Sub Regional RTEP Committee PJM West

July 17, 2020

Project Update

Baseline Scope change: B3100, Previously presented in 1/11/19 and 2/20/19 SRRETP

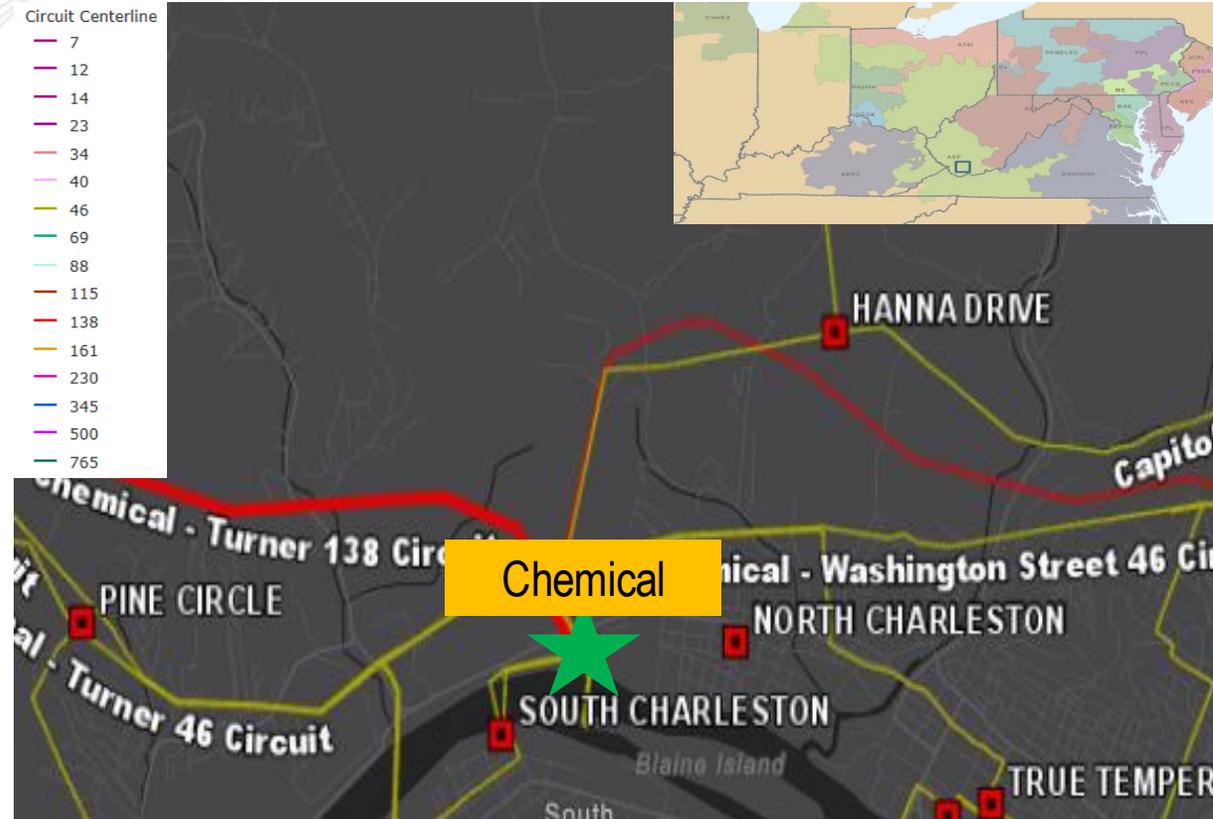
~~Replace 138kV MOAB switch “YY” with a new 138kV circuit switcher on the high side of Chemical XFR #6.~~

Relocate 138 kV circuit breaker W between 138 kV bus #1 extension and bus #2. Install a new 138 kV circuit breaker between bus #1 and bus #1 extension.

Reason for the change: The baseline solution was re-visited as AEP completed engineering for the supplemental solution (AEP-2018-AP018 and AEP-2019-AP010). Instead of installing a switcher only on the high side of the transformer, AEP installs a breaker in series with existing breaker W to create another high side bus to serve the 138/46 kV transformer. The cost is the same; it only affects the layout of the high side of the station. As outlined in the ancillary benefits though, it allows for much greater operational flexibility.

Baseline Scope Change: B3116, Previously presented 2/20/19 and 5/20/19 in SRRTEP

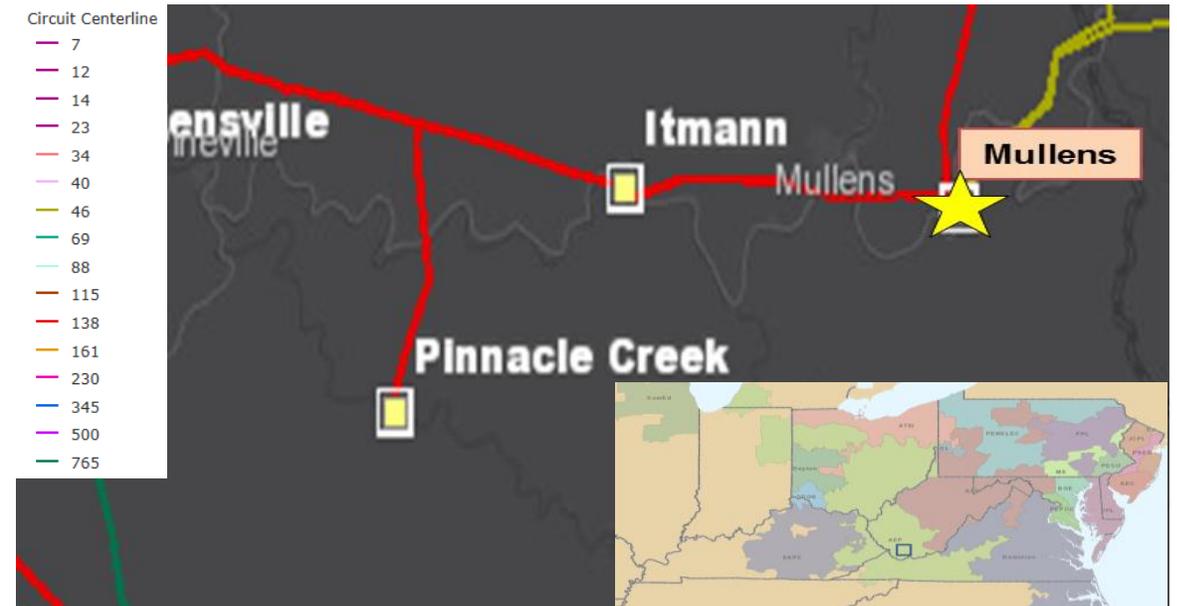
Replace existing 138/46kV 30 MVA transformer #4 and associated protective equipment with a with a new 138/46 kV 90 MVA transformer and associated protective equipment. **Install required high side transformer protection by replacing the existing ground switch MOAB with a new 138 kV high side circuit breaker.**

Total Estimated Transmission Cost: ~~\$3.0M~~ \$4.0M

Reason for the change: It's a scope clarification to include that piece of the baseline solution. When replacing the transformer, the existing high side ground switch MOAB will also be replaced with a circuit switcher. This is considered baseline work because it is required with the replacement of the transformer.

Baseline Project Cancellation: B2594, Previously presented in 1/7/15 TEAC

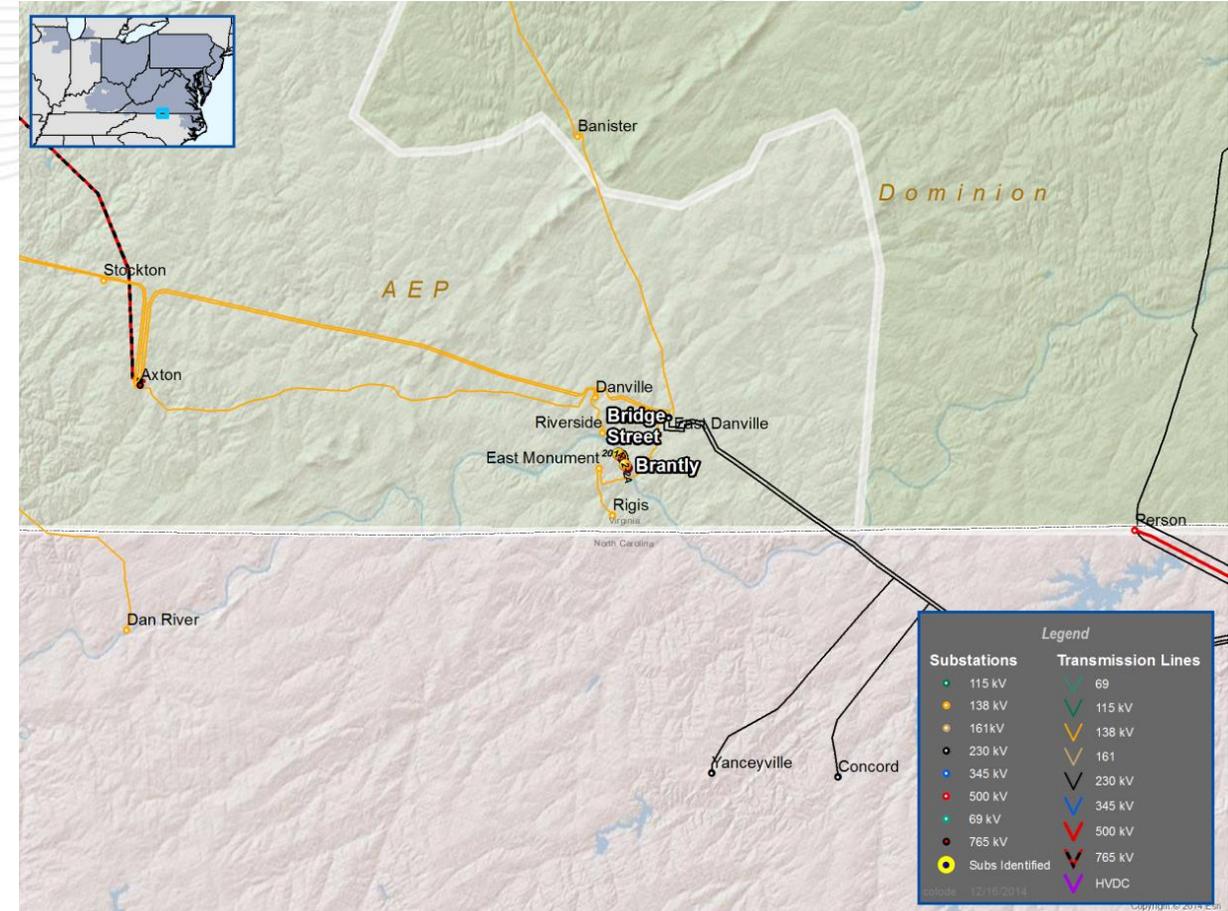
Reason for the Cancellation: The line is entirely owned by Danville, not AEP. This is not a PJM tariff facility.

Baseline Scope Change: B3040.6, Previously presented 8/31/19 and 9/28/19 in SRRTEP

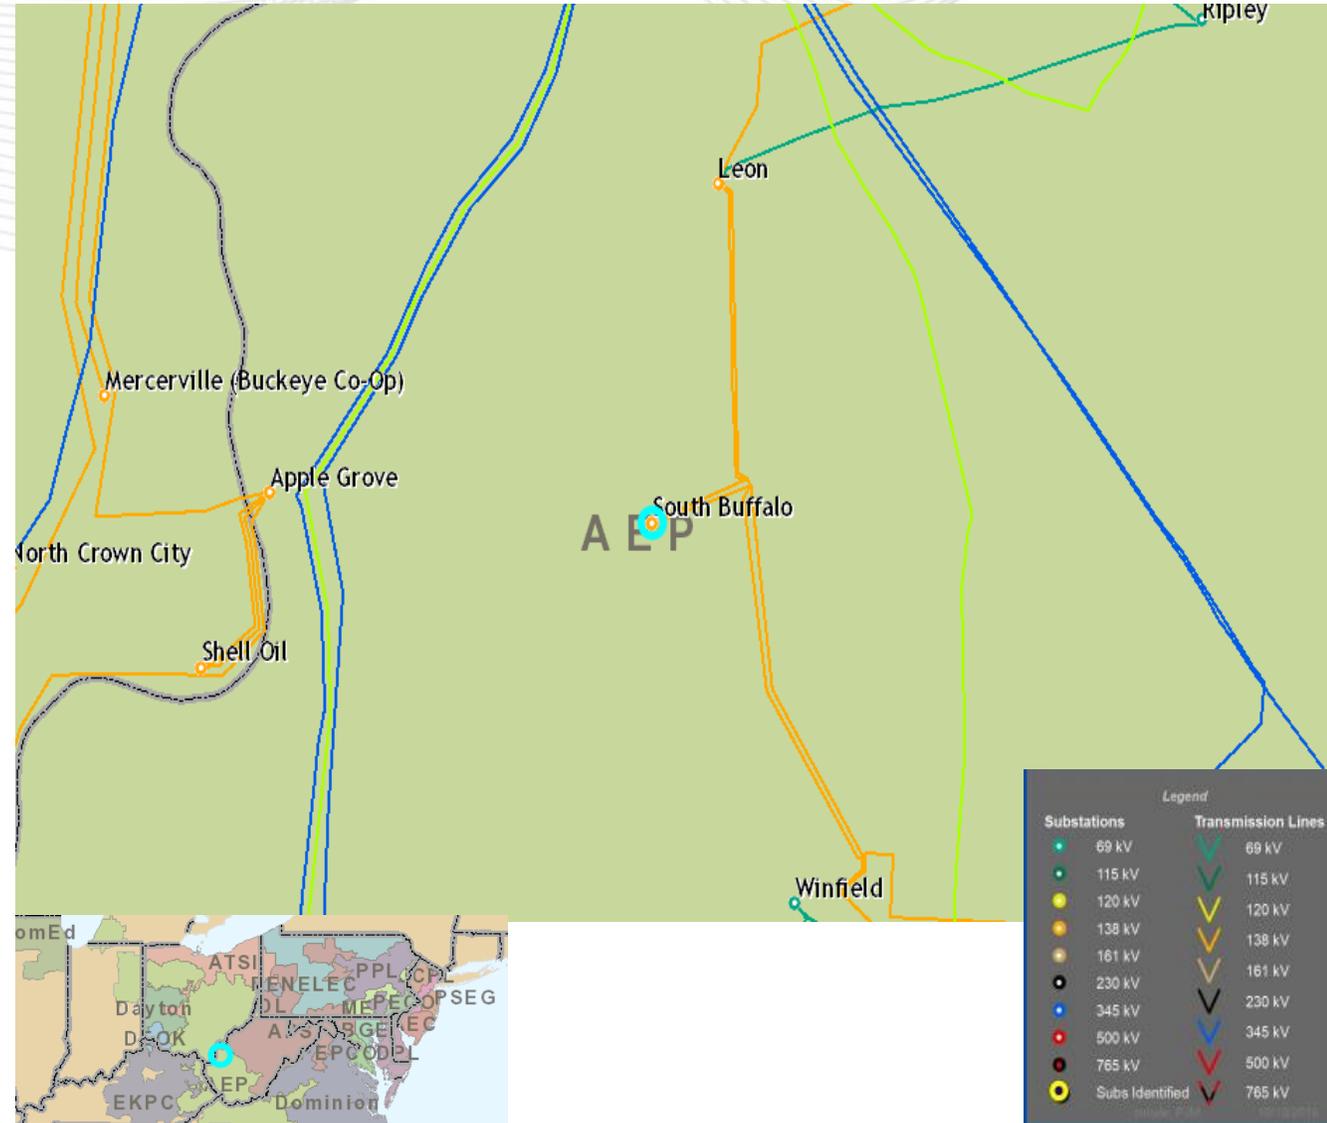
Original Scope: South Buffalo: Install 28.8 MVAR Cap Bank
New Scope: South Buffalo: Install 34.6 MVAR Cap Bank

Reason for the Change: AEP, in working with vendors to ensure the most cost effective equipment is available, changed their standard equipment list with respect to capacitor banks. 28.8 MVAR capacitor banks were removed as part of this review, so the next size available is 34.6 MVAR. This change has no cost impact on the project and is re-presented here due to the required change to future cases.
